MORIN BUILDING
8570 EXECUTIVE PARK AVENUE
FAIRFAX, VIRGINIA 22116-0815

Subject: Addendum # 2 to IFB #18-53, Lee Highway Transmission Main

**IFB No. 18-53
PROJECT 2545, DIVISION 2
LEE HIGHWAY TRANSMISSION MAIN**

Contract Item 6b
Scale: 1"=25' Horiz.

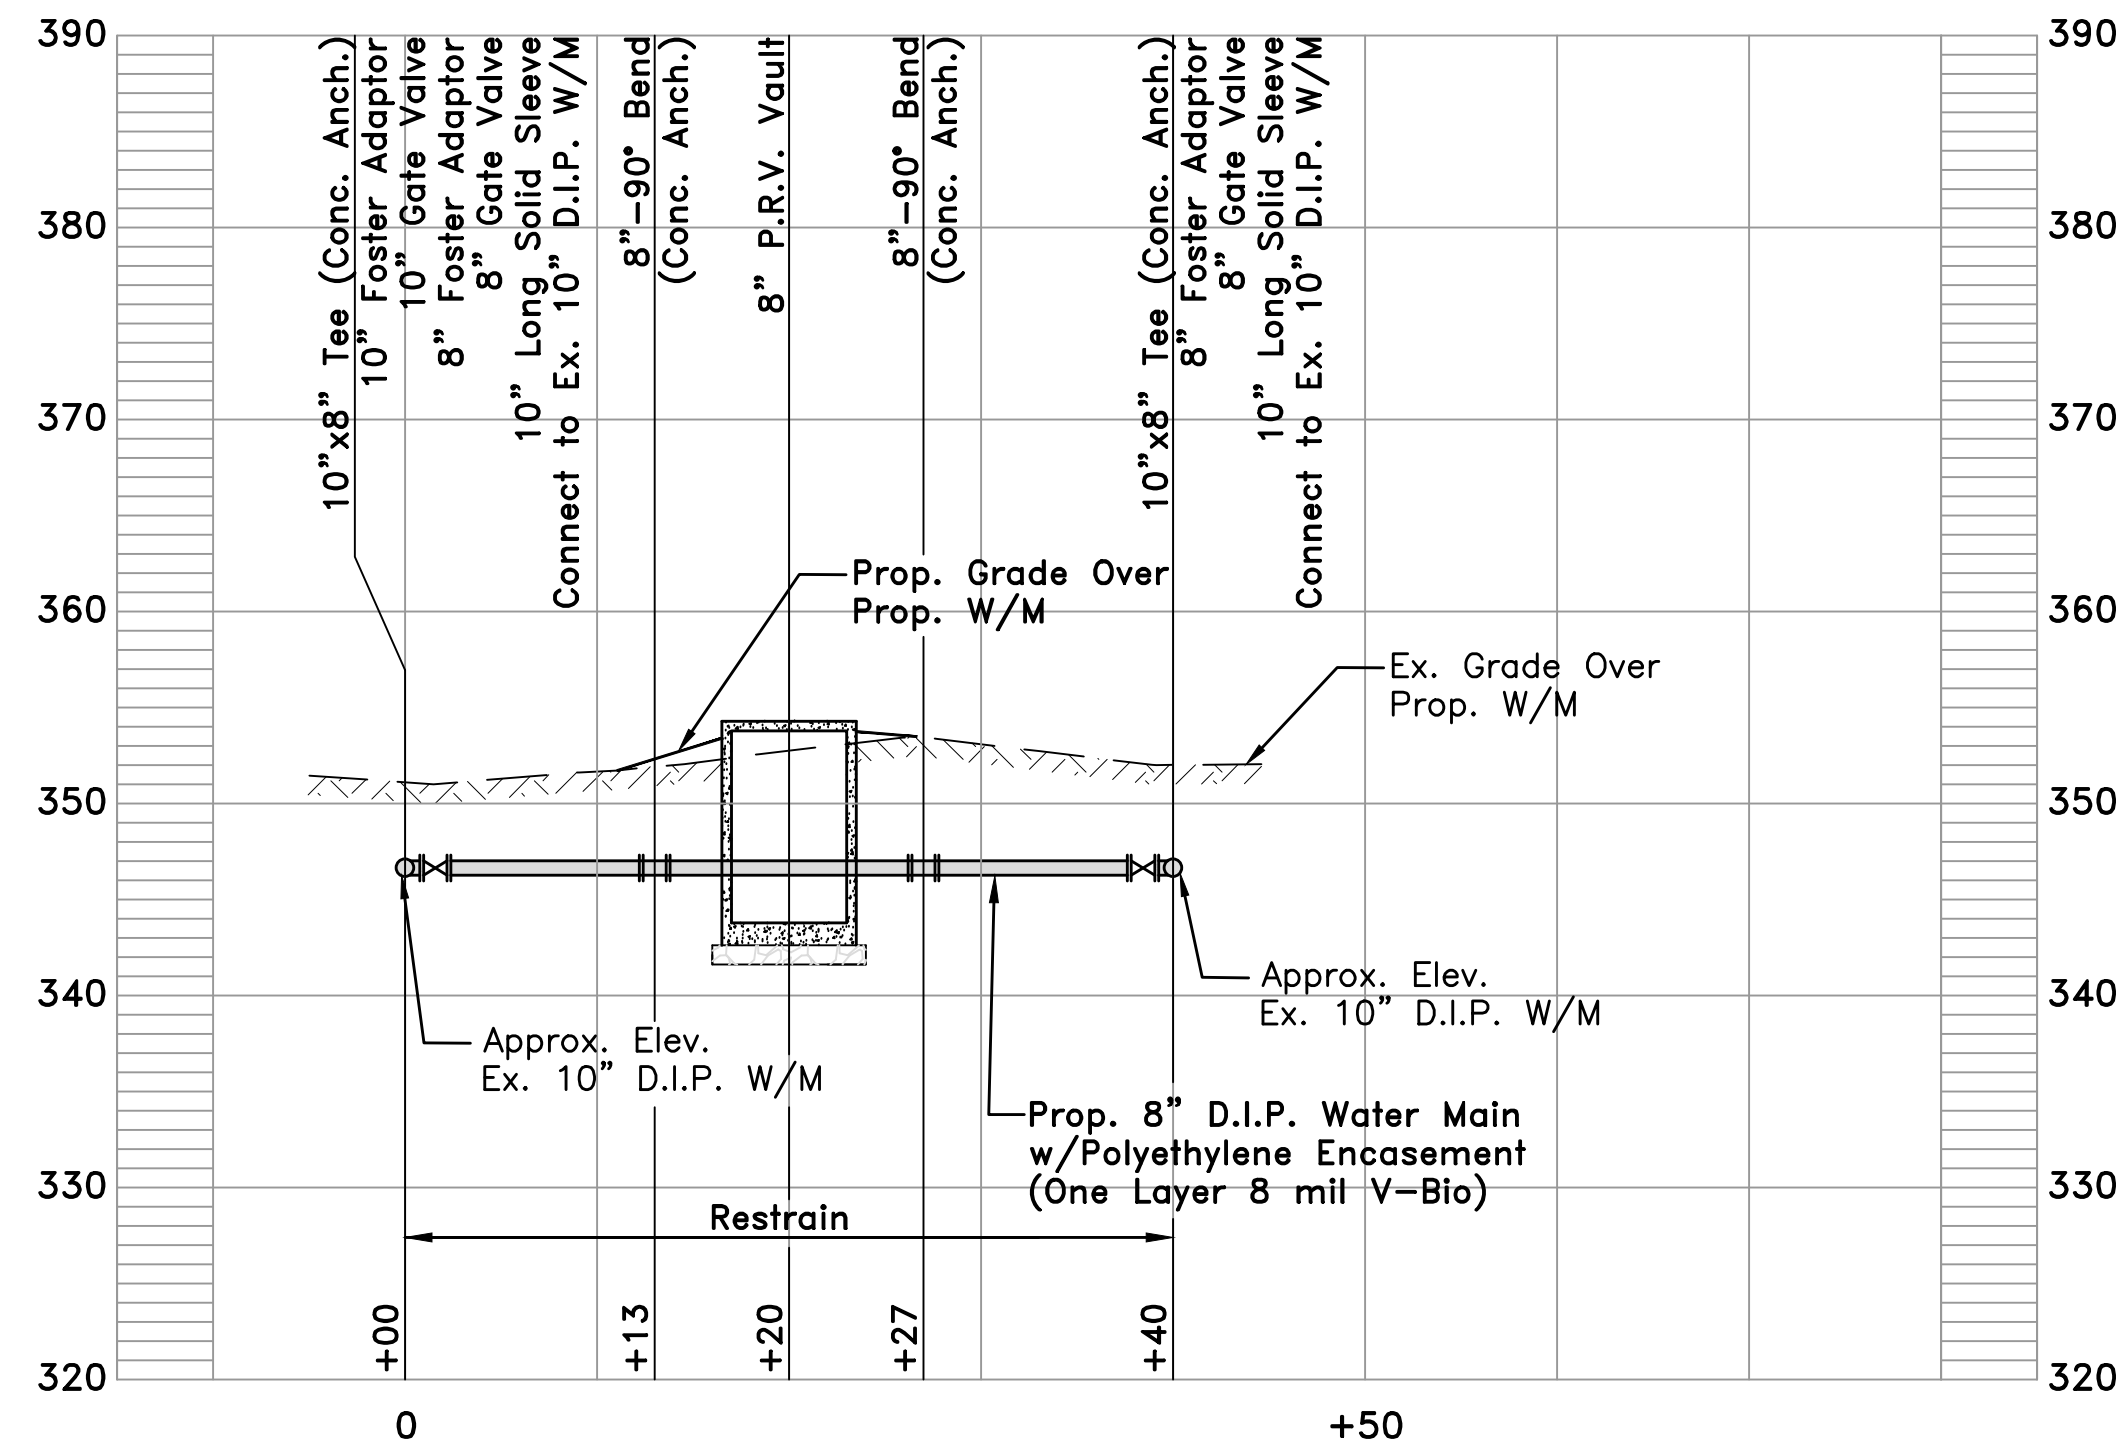
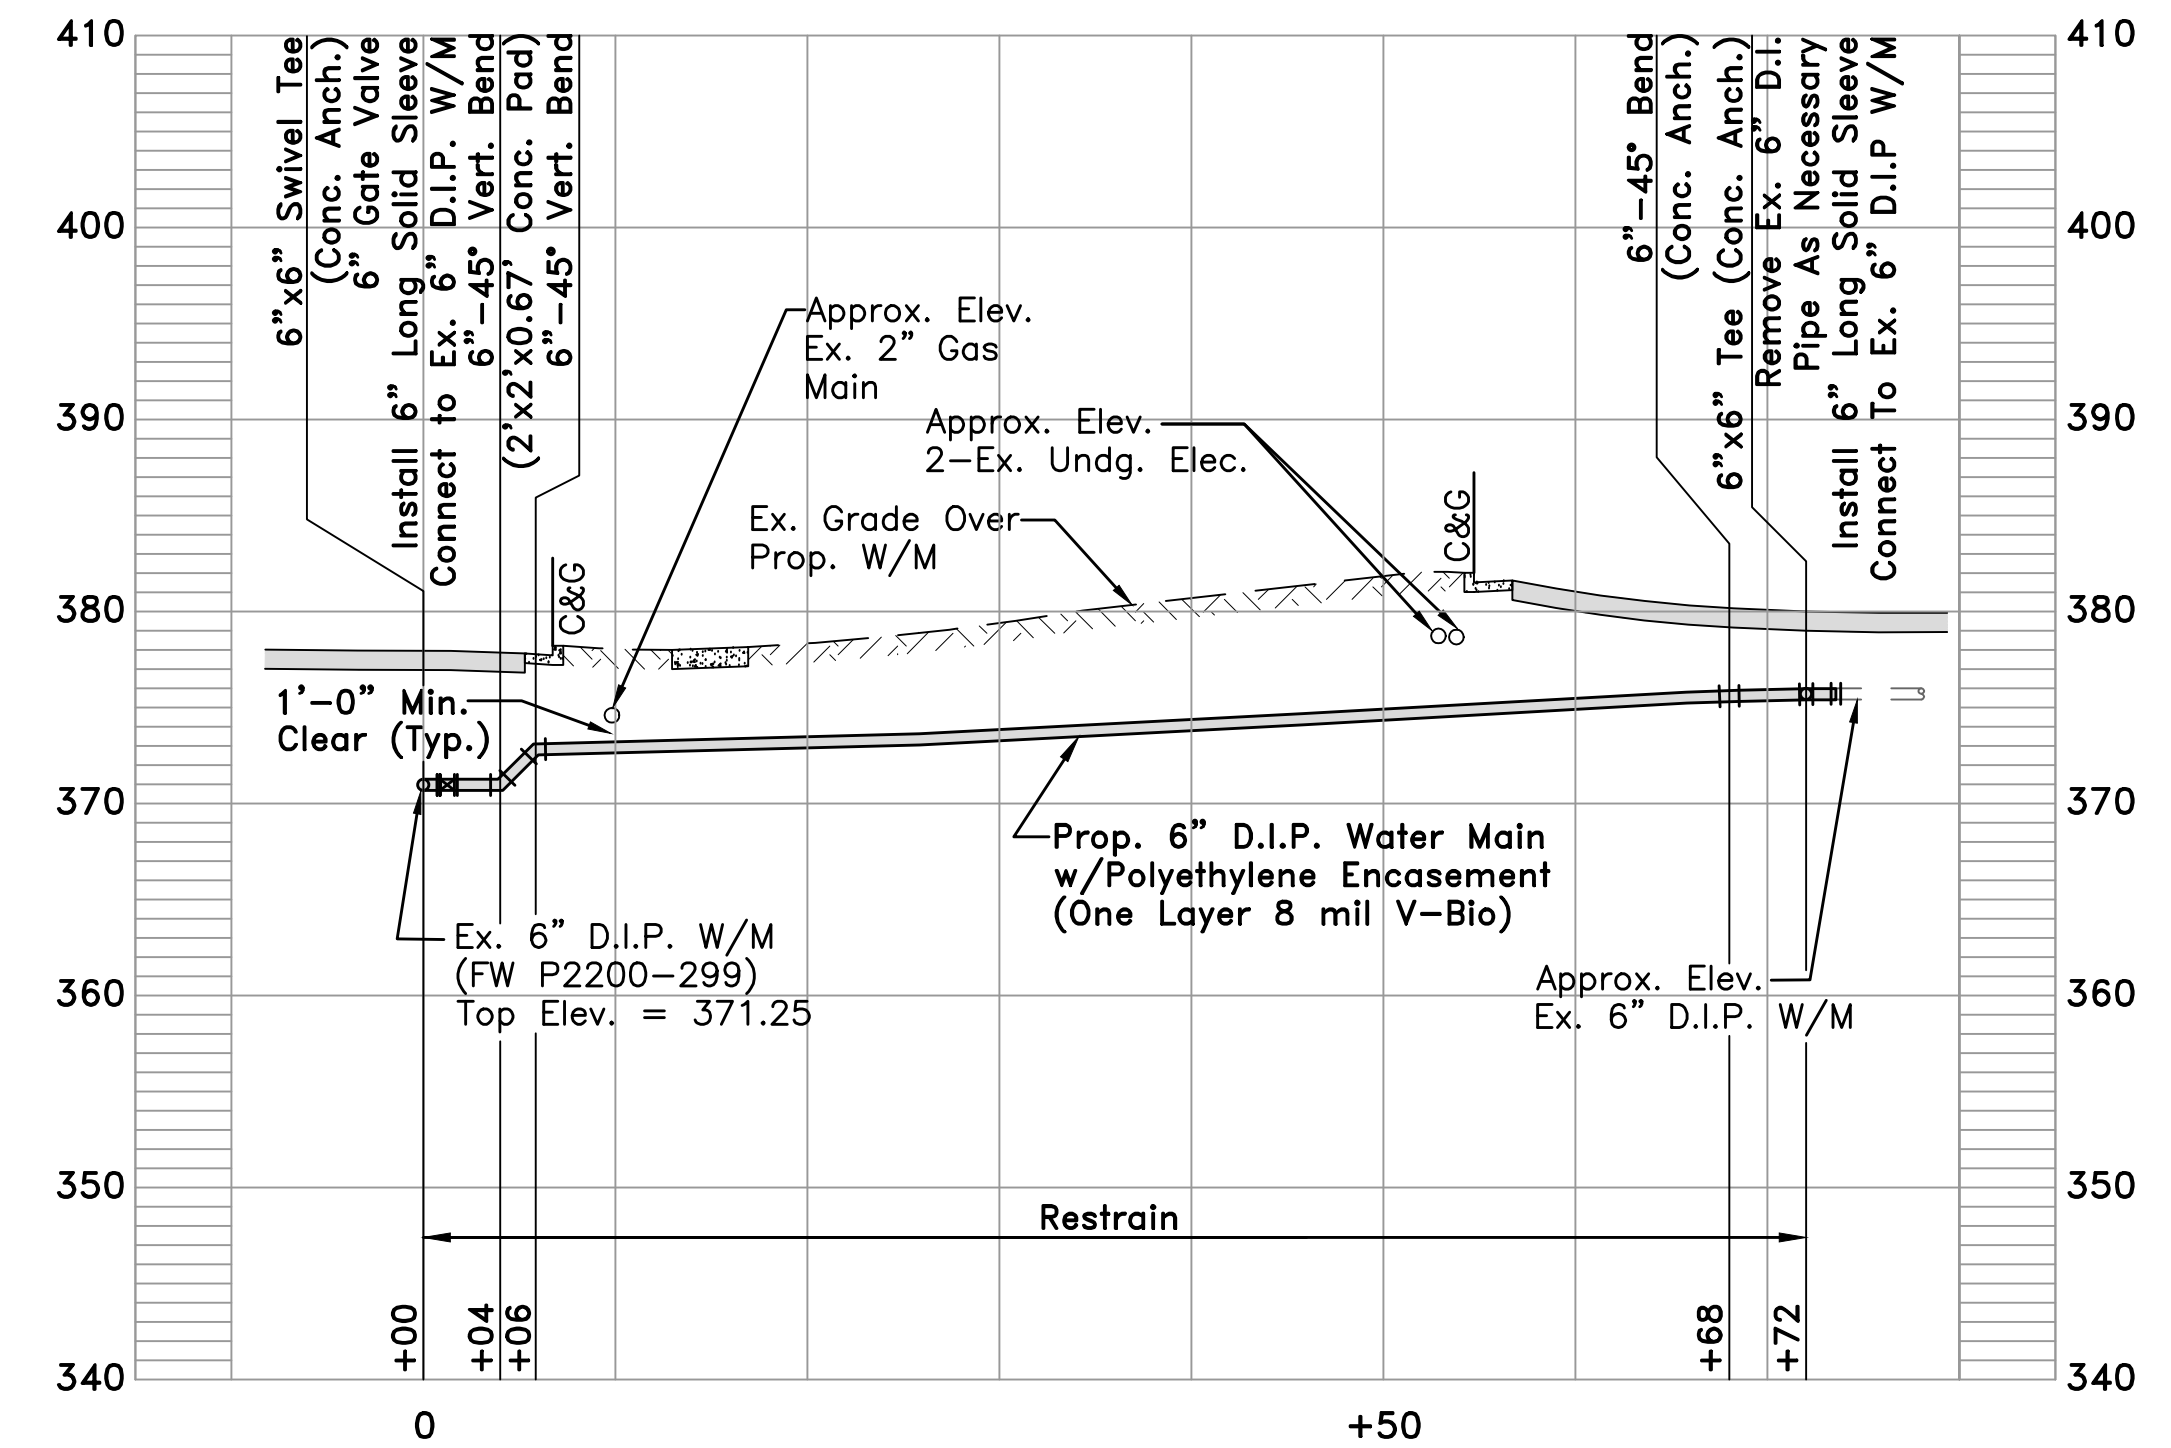
6/27/18	Addendum No. 2 - Added Ex. Check Valve Vault Dimensions
NO.	DATE
